Bid Bulletin #03

PROJECT: Weeping Water Public Schools
Additions & Renovations
Weeping Water, NE

RE: Addendum No. 2 to the Bidding Documents for:
Weeping Water Public Schools
Additions & Renovation
204 West O Street
Weeping Water, Nebraska 68463
Schemmer Project No. 06368.001

This addendum consists of nine 9 pages of written addendum items and thirty-three 33 pages of supplemental drawings.

SHEET NO: SDM-2

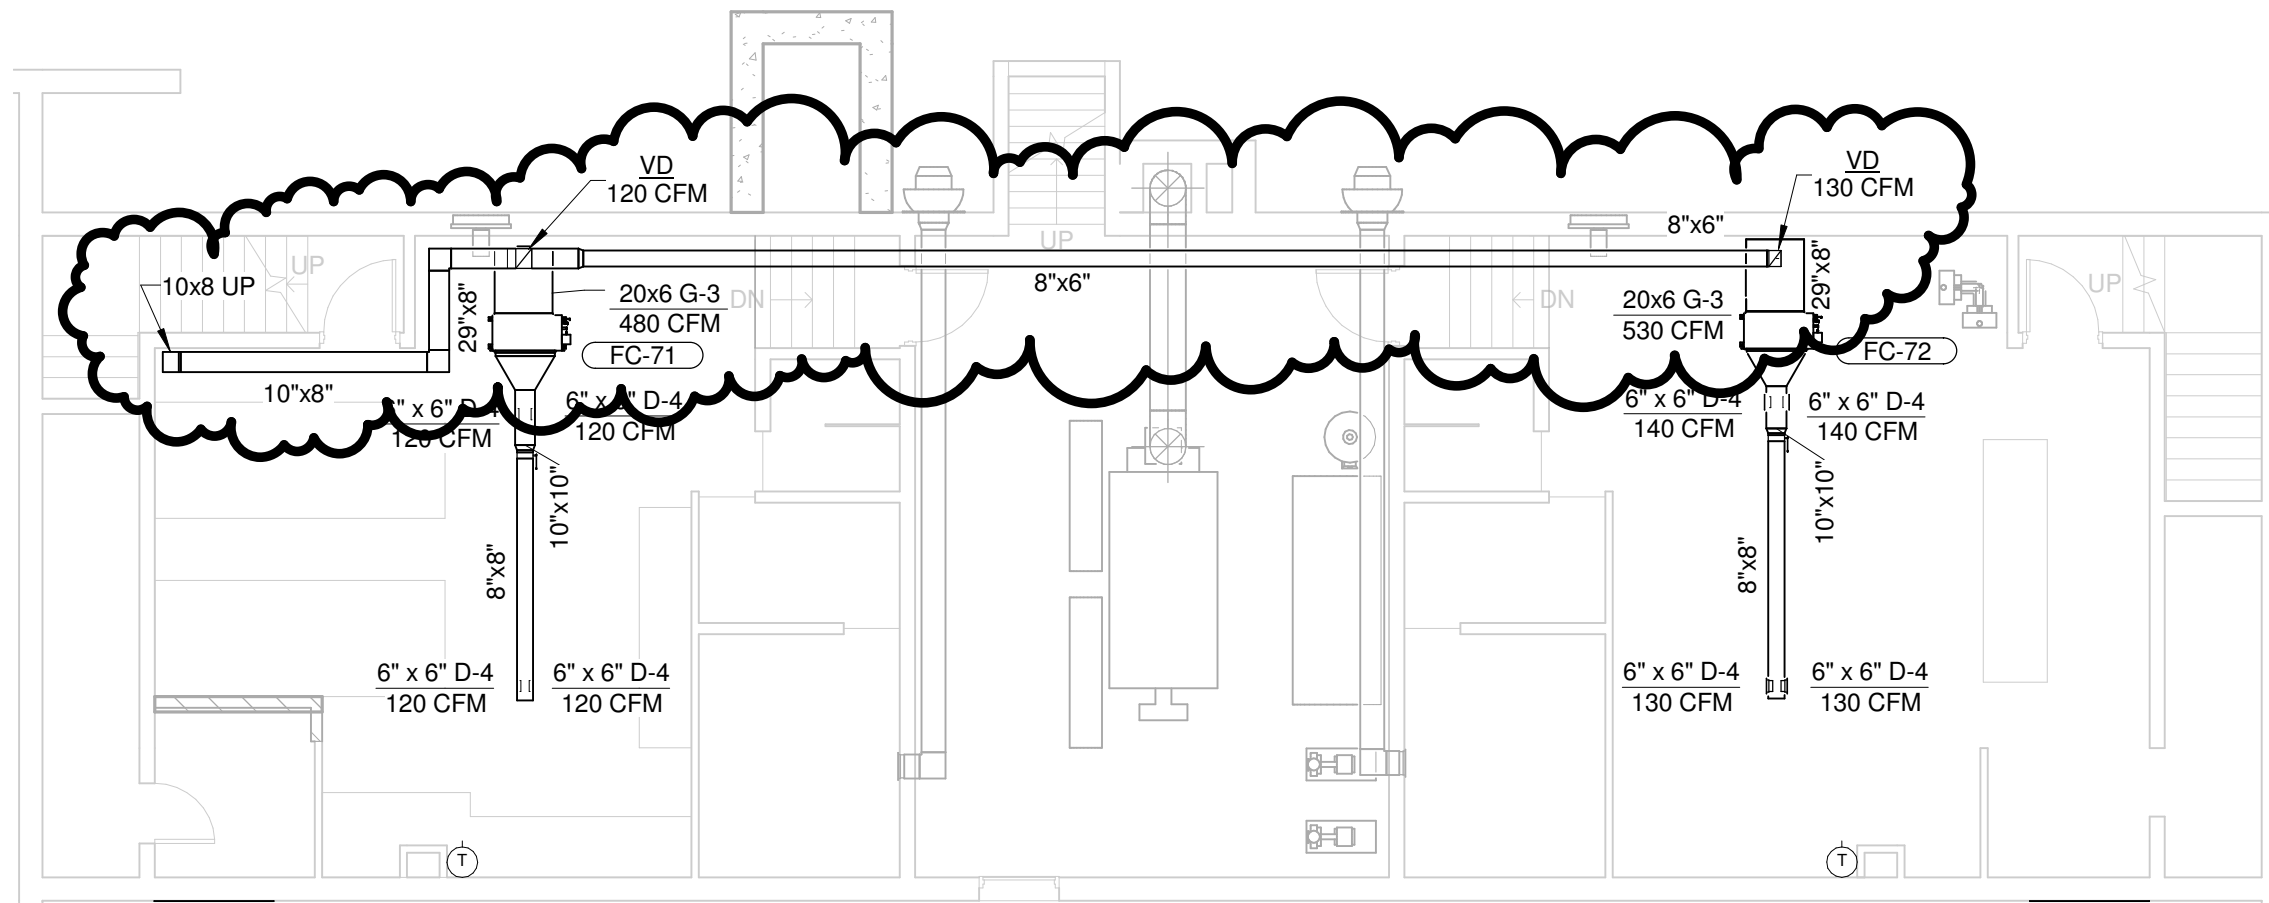
Item No. DM-4, Sheet M1-01

- 1) See supplemental drawings SDM-1 and SDM-2 for added content to this sheet.

SHEET NO: SDM-3

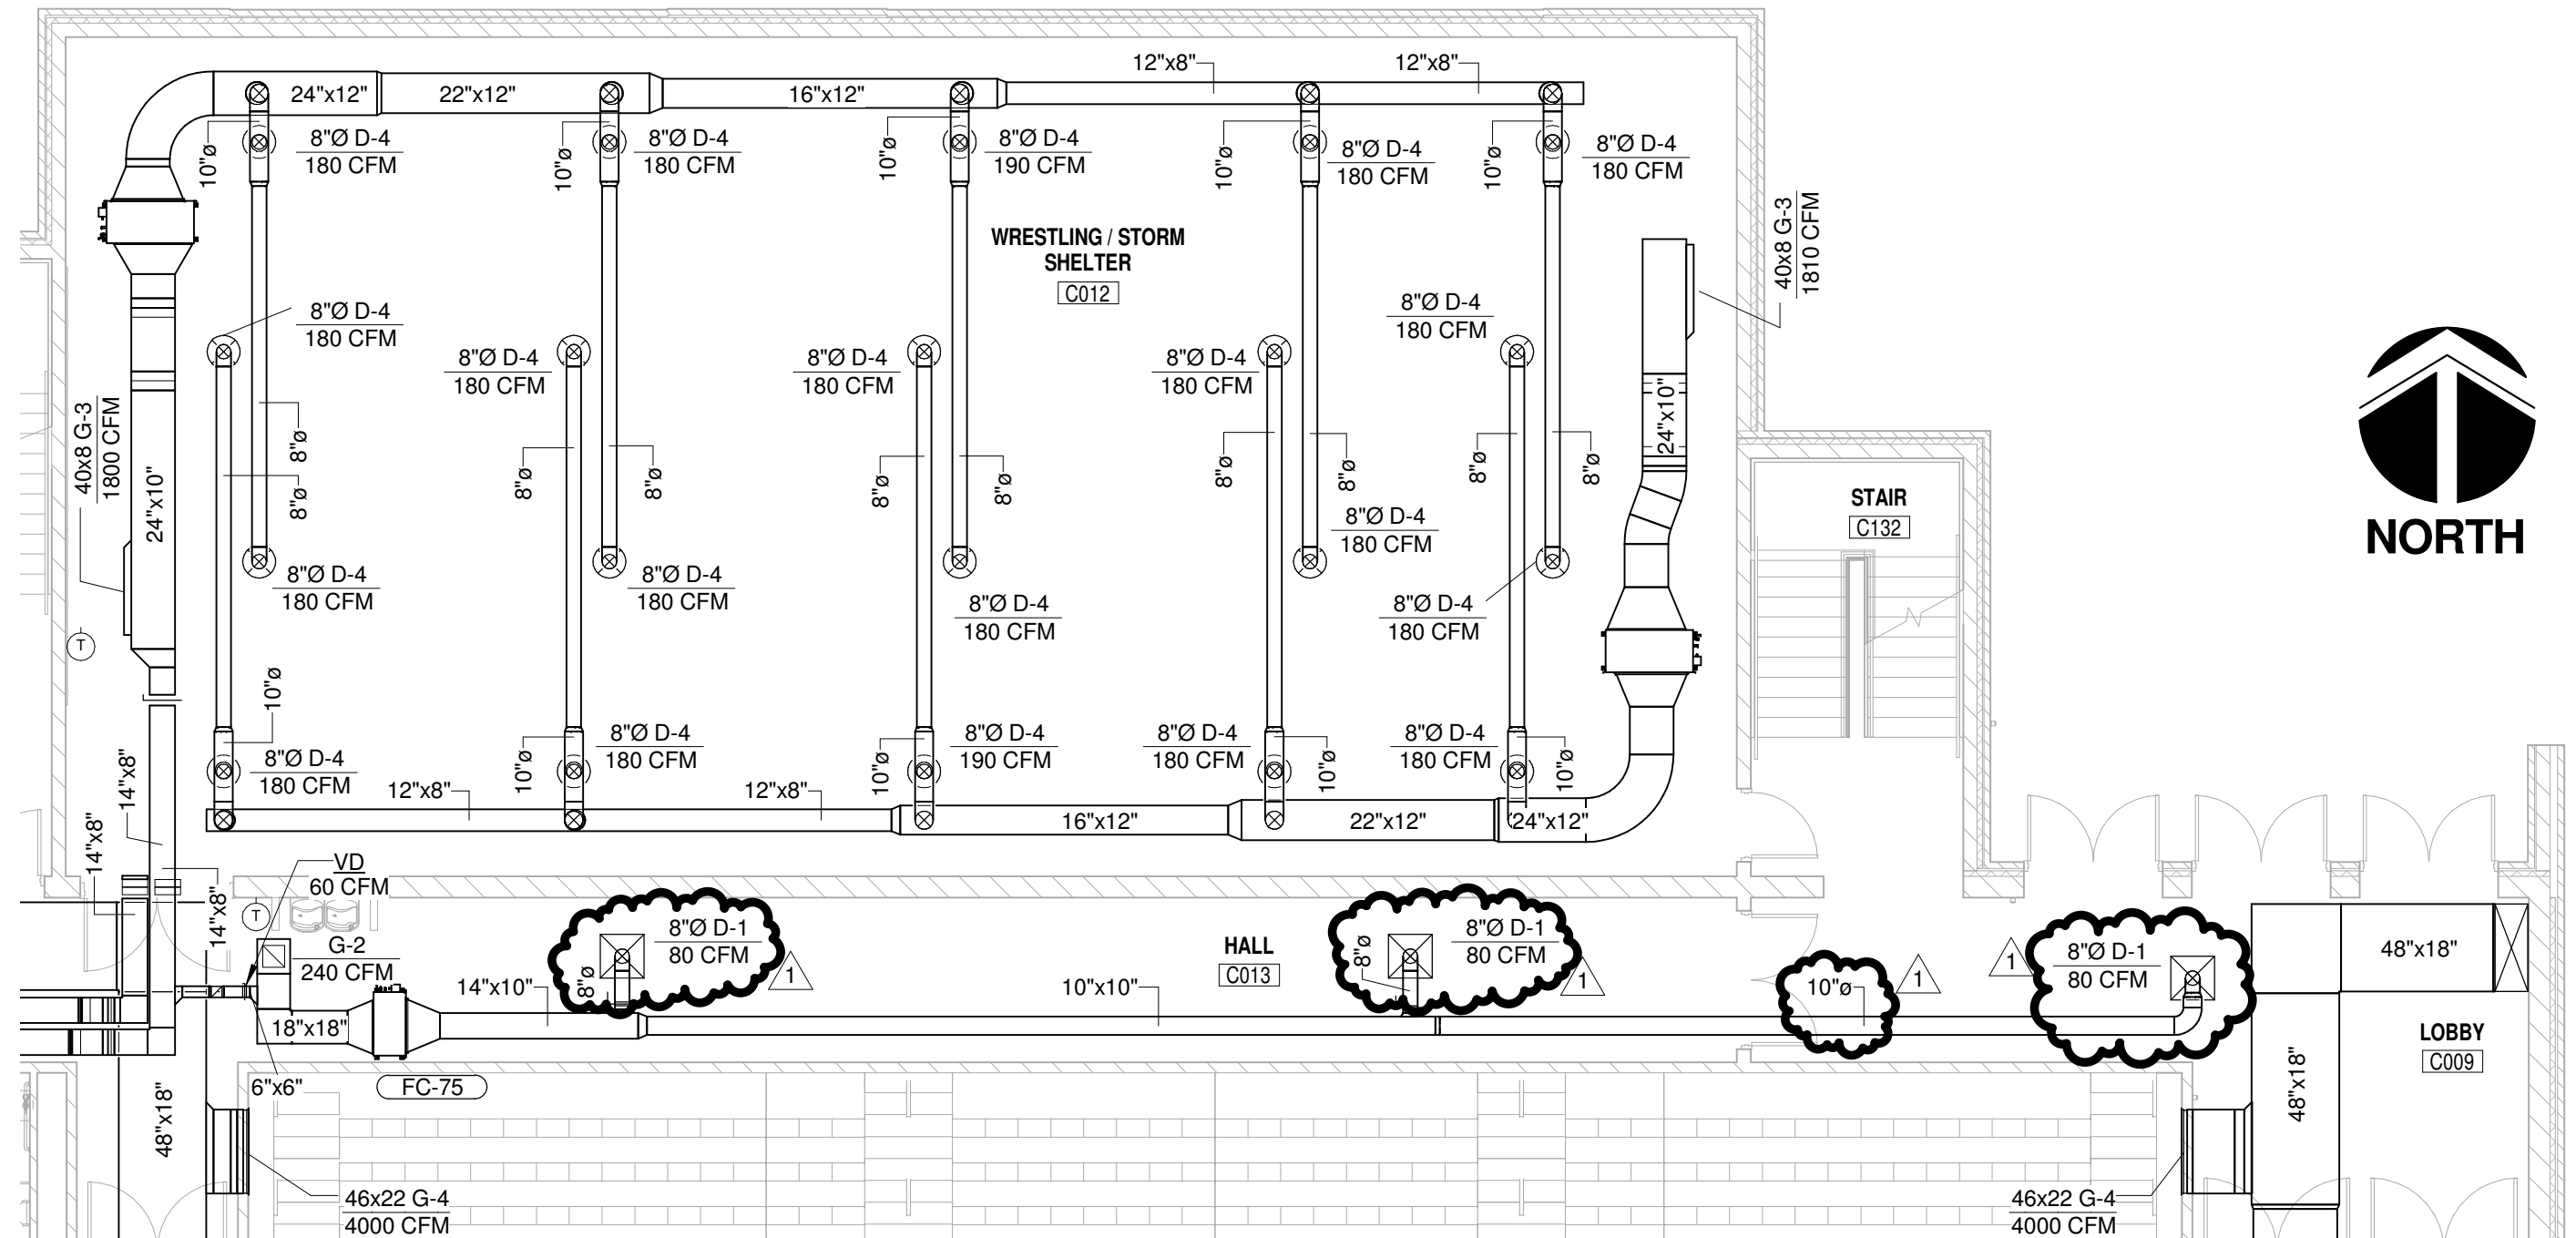
Item No. DM-5, Sheet M1-02

- 1) See supplemental drawings SDM-3 and SDM-4 for added content to this sheet.

SHEET NO: SDM-5

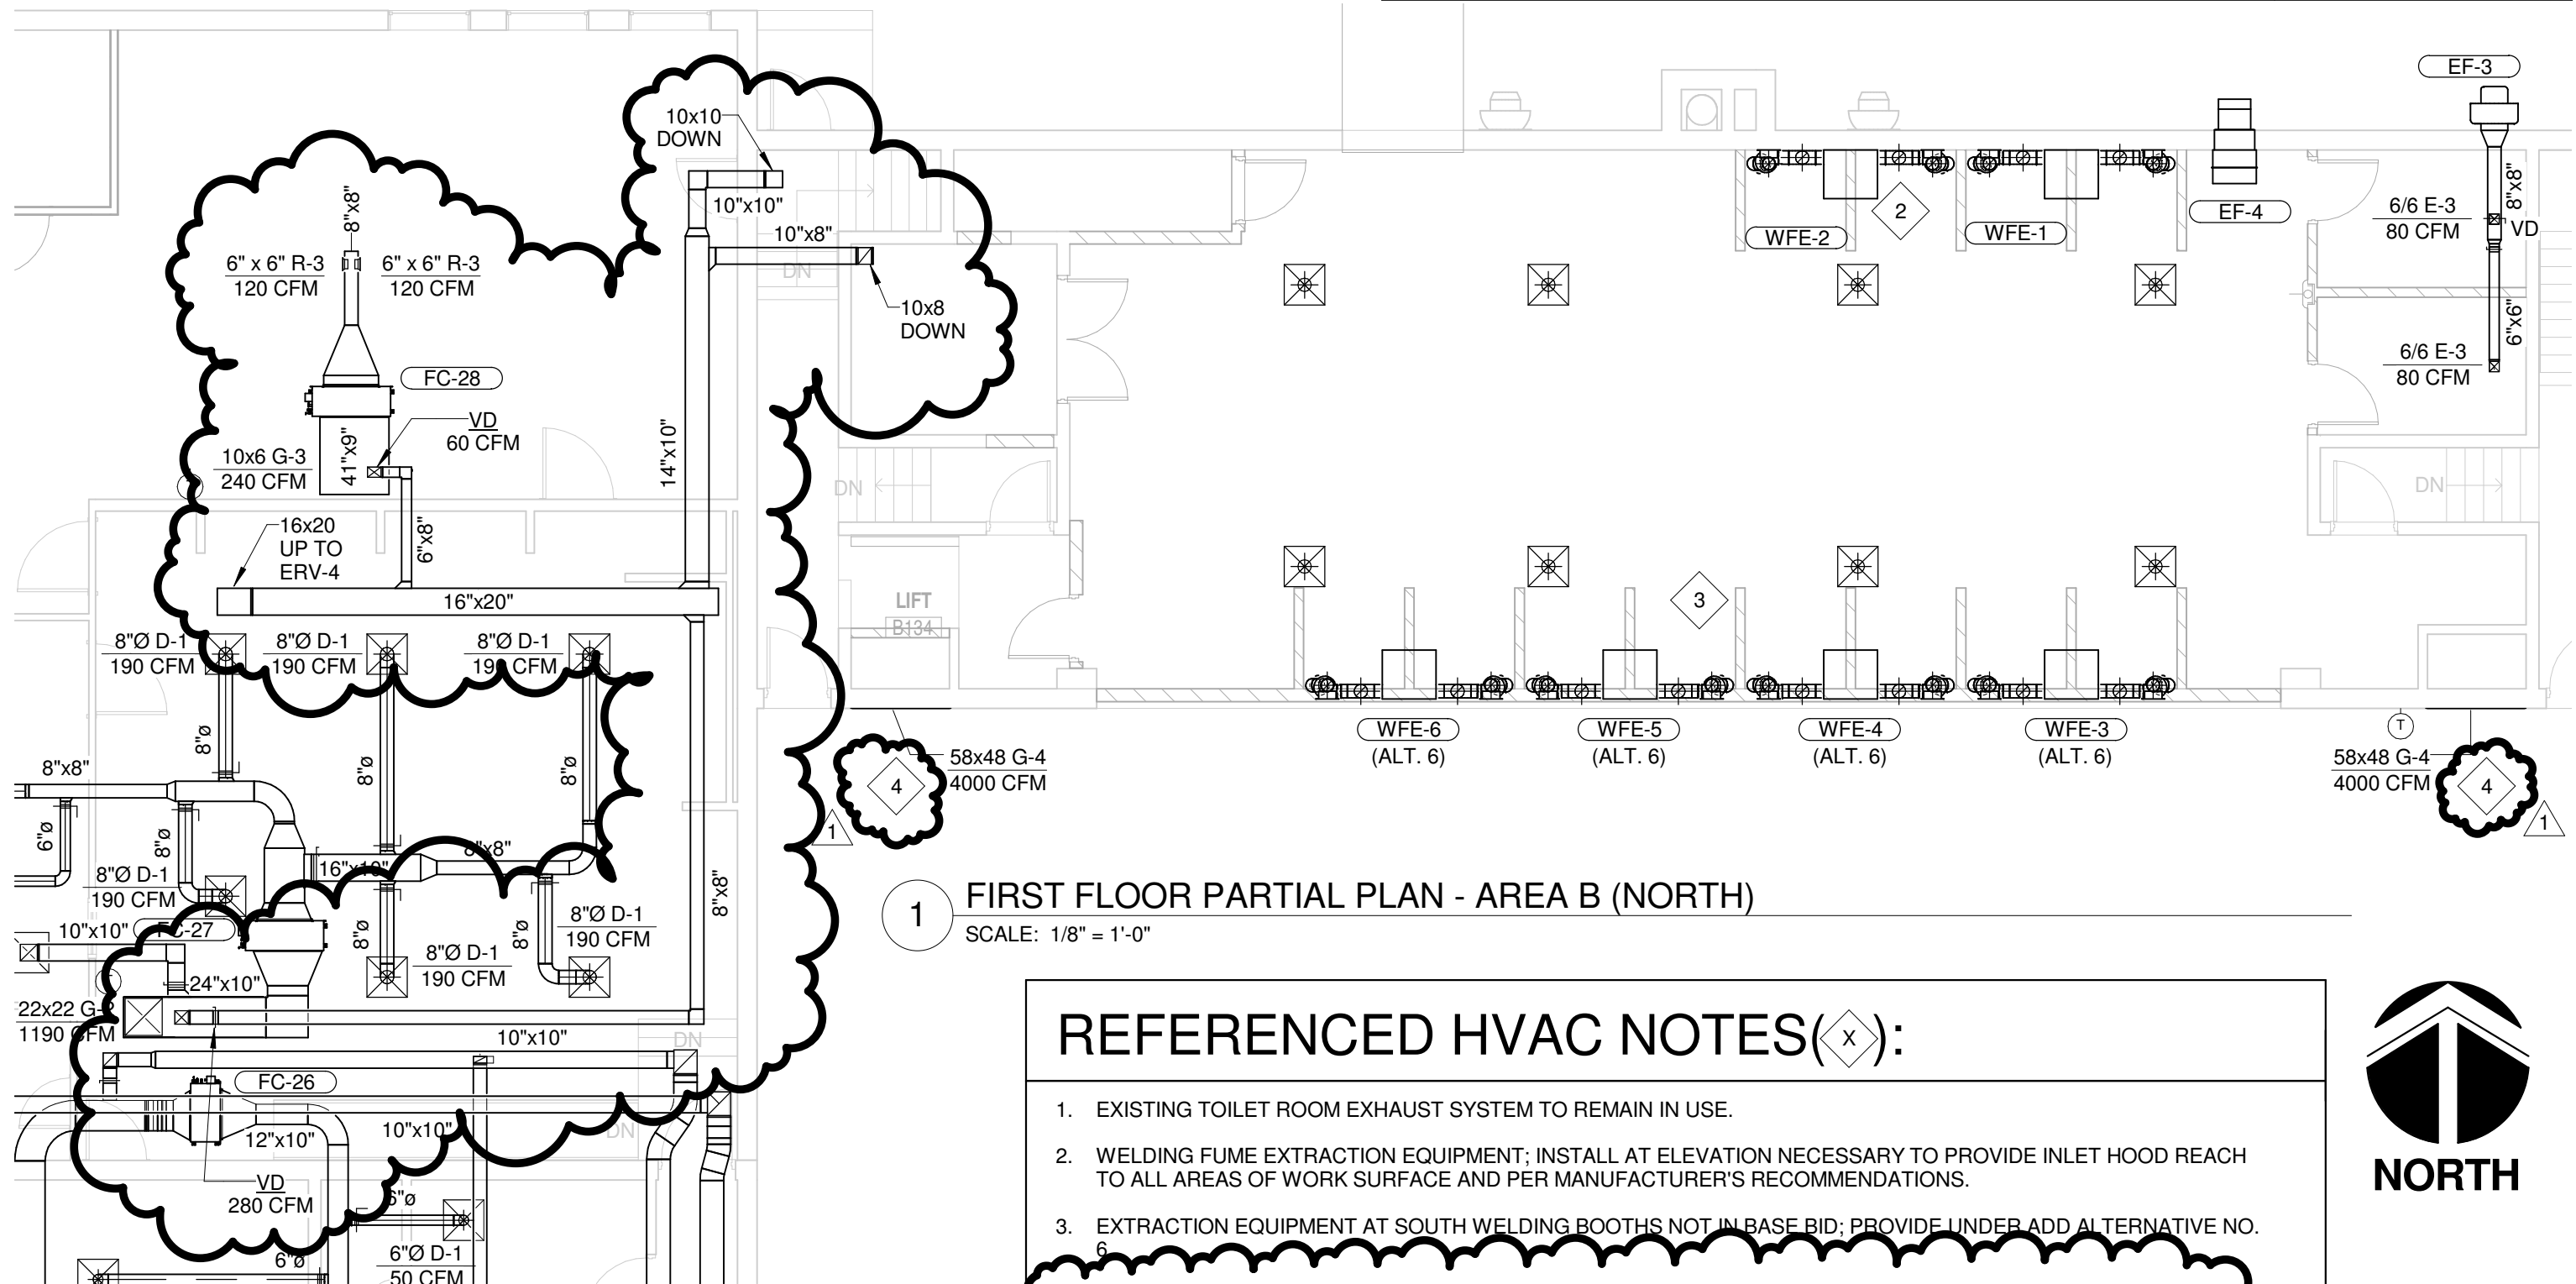
Item no. DM-3, Sheet M1-04

- 1) Add the following to Referenced HVAC Note 2:
"EQUIPMENT SHALL BE LINCOLN ELECTRIC STATIFLEX 200-M K1654-2, DUAL ARM
FITRATION UNIT, WITH TWO LFA 2.0 K1655-5 EXTRACTION ARMS AND WALL MOUNTING
KITS."

Item No. DM-6, Sheet M1-04

- 1) See supplemental drawings SDM-5 and SDM-6 for added content to this sheet.
